Beech Aircraft Corporation
Wichita 1, Kansas

0-49-43

TO ALL BEEHCRAFT BONANZA OWNERS:

Starter Modification

Fig. 1

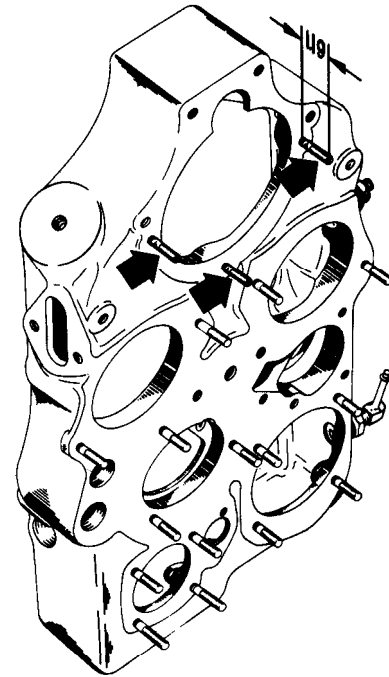
I. ACCESSORY CASE MODIFICATION (Fig.1)

A. Remove the three studs indicated by arrow from starter mounting pad, and replace with three oversize studs, Part No. 531005-003, identified by pointed end. Set studs to 1.19 inch height above face of accessory case. Do not drive studs in to shoulder, drive to height shown.

After the modifications to the crankcase are completed in accordance with Step 4 of this bulletin, reassemble the accessory case on the crankcase, using a new gasket, Part No. 352069.

B. After the accessory case has been reinstalled on the crankcase, install gaskets, adapter plate, and starter as shown below.

Fig. 3

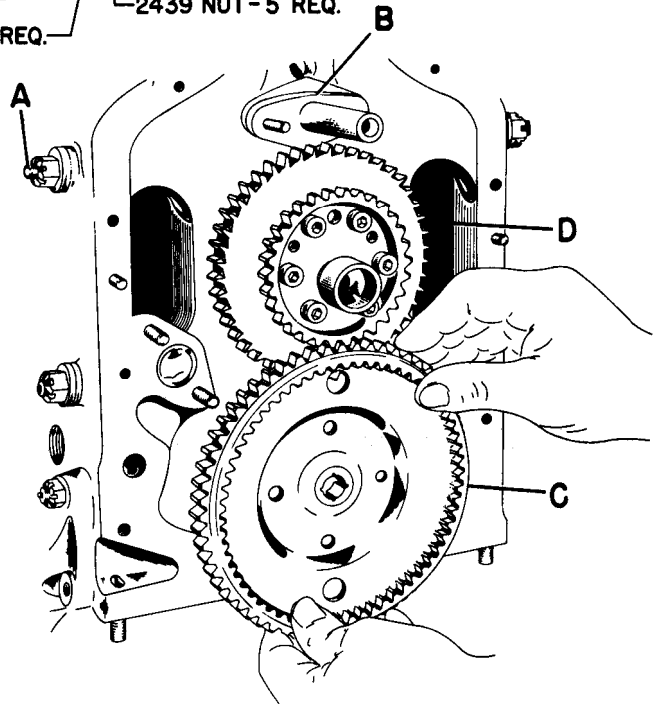
II. CRANKCASE MODIFICATION (Fig. 3)

- A. Loosen top rear crankcase through bolt.
- B. Remove cotter pins, castle nuts, and starter pivot; remove starter pivot studs from crankcase; and discard all the above parts.
- C. Remove cam drive gear; do not discard.
- D. Remove accessory drive gear and discard.

Fig. 4

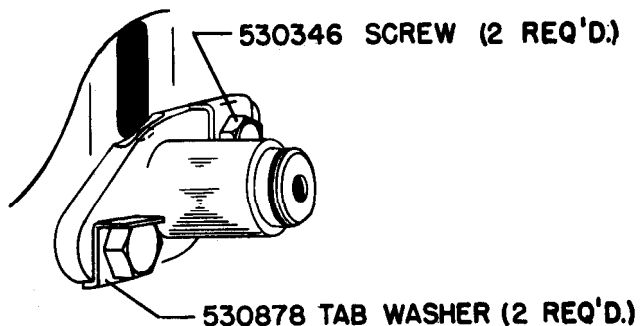
E. Install 530343 starter pivot assembly with two each 530346 screws and 530878 tab washers as shown in Fig. 4. Bend tab washers as shown to lock screws.

NOTE: The 530343 starter pivot must fit tightly in the hole in the crankcase. On a few engines, the hole is reamed .010 oversize, and these engines are identified by an .010 stamped adjacent to the hole. Special .010 oversize pivots may be ordered from the Parts Sales Department of Beech Aircraft Corporation for these engines. The airplane and engine serial numbers must be furnished when ordering these special pivots.

Fig. 5

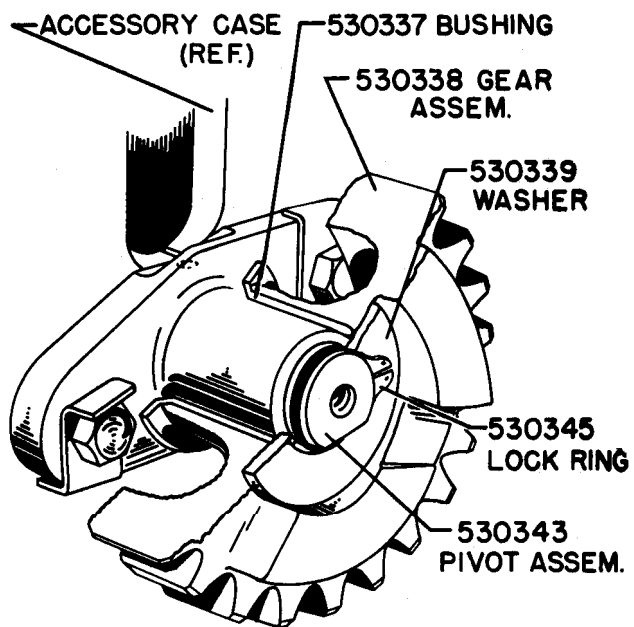
G. Install starter gear assembly 530338 with 530339 washer and 530345 lock ring as shown in Fig. 5.

Fig. 6

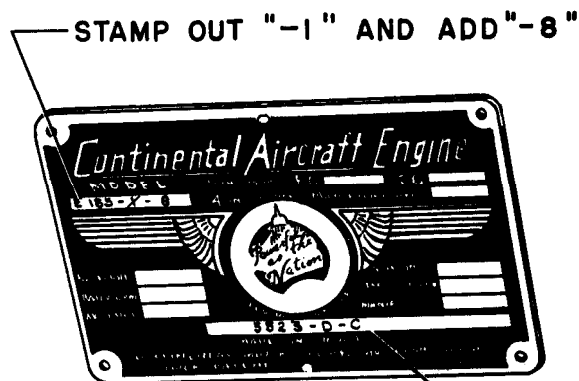
Accomplishment of the above modifications changes the engine designation from E-185-1 to E-185-8. Also stamp a 'C' after the serial number to denote conversion (Fig. 6). Change the engine nameplate, the engine log book, and the airplane log book to agree. A Repair and Alteration form, Form 337, must be accomplished for this modification. The total weight change is a reduction of two pounds at a moment arm of 44 inches.

Fig. 7

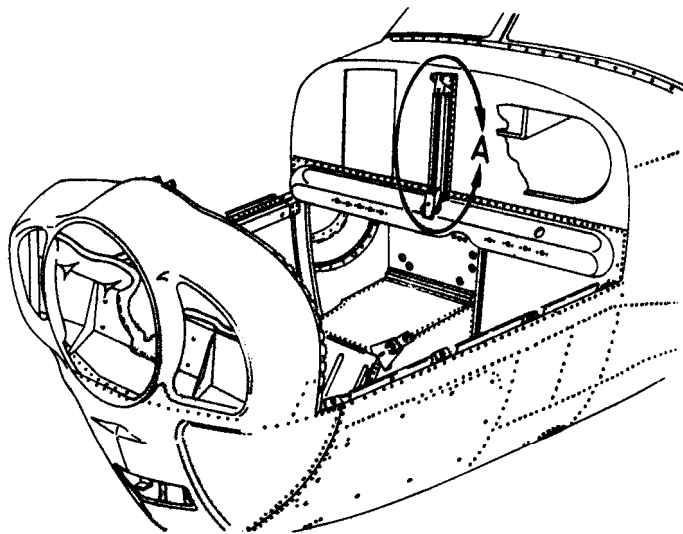
A. Rework of firewall center channel - all serial numbers. With the engine and hood removed, rework the firewall center channel as shown in fig. 7 and Fig. 8.

1. Measure one inch forward of firewall.
2. Measure 4-1/4 inch down from top of center channel.

Cut out front portion of channel for a distance of 7-5/8 inches as shown.

4. Locate angle reinforcement No. 35-415379, 1/4 inch up from top of cross duct and fasten with eight 1/8-inch rivets in pilot hole locations, two reinforcements required. Cutout on angle is located on right-hand side to clear starter relay.

Fig. 9

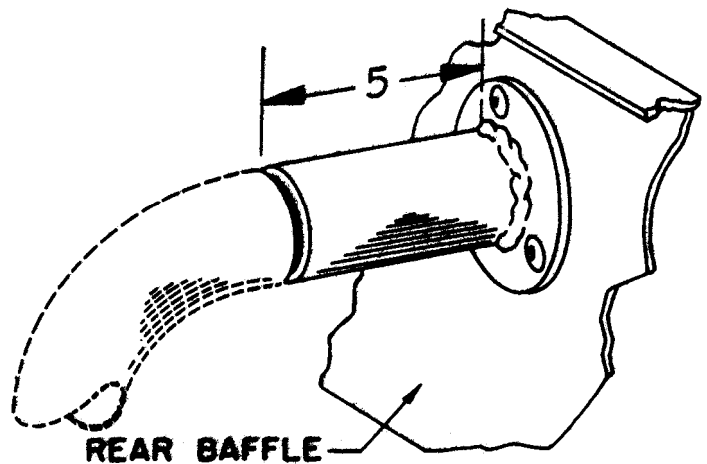
Cut off present generator blast tube as shown Fig. 9.

- b. Install plastic hose supplied in kit on blast tube inlet on firewall and on generator, and route tube around outside of magneto. Rotate the brush cover on the generator so the plastic tube has no sharp bends. Fasten with clamps provided in kit.

TO BATTERY SWITCH
DIAGRAM E80 STARTER CIRCUIT
AIRPLANE SERIAL D1 TO D1116 INCL.
Fig. 10

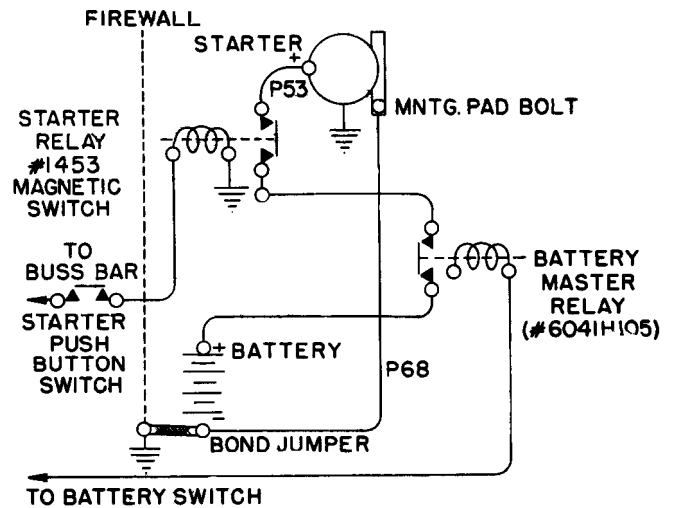
1. Serial D-1 to D-1116, inclusive. (Fig. 10)
These instructions assume that Service Letter No. 10 has been accomplished.

- a. Attach Wire P-53 to (✓) terminal on starter.
- b. Attach one end of new Wire P-68 to battery 'negative' at firewall stud.
- c. Attach other end of P-68 under nut on starter mounting pad.

Fig. 11

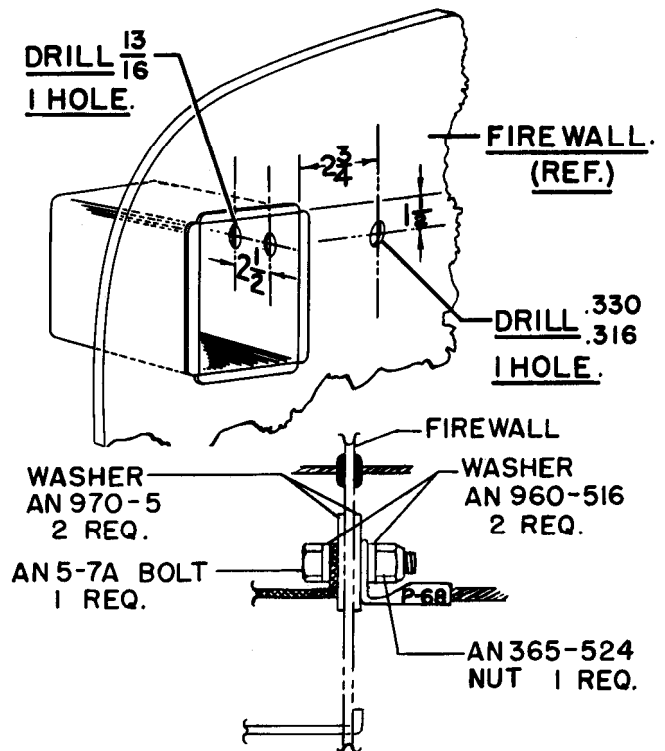
- a. Attach Wire P-53 to (✓) terminal on starter.
- b. Remove battery and battery box from airplane and drill holes in box and firewall as in Fig. 11.
- c. Install stud in firewall as shown.
- d. Attach one end of new Wire P-68 to stud at forward side of firewall, fasten other end under starter mounting nut.
- e. Install AN931-9-5-13 grommet in hole in side of battery box, reinstall battery box, and install battery ground strap from (-) battery post to stud in firewall.

Fig. 12

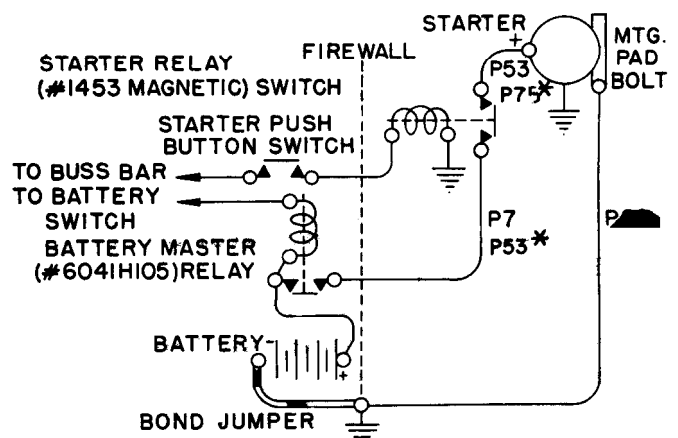
3. Serial D-1885 and After. (Fig. 12)

- a. Fasten one end of Wire P-53 to large post on starter magnetic switch. The other end of P-53 remains attached to the battery master relay.
- b. Install new Wire P-75 (2-gauge copper, eight inches long) from the other large post on starter magnetic switch to the (✓) terminal on the starter.
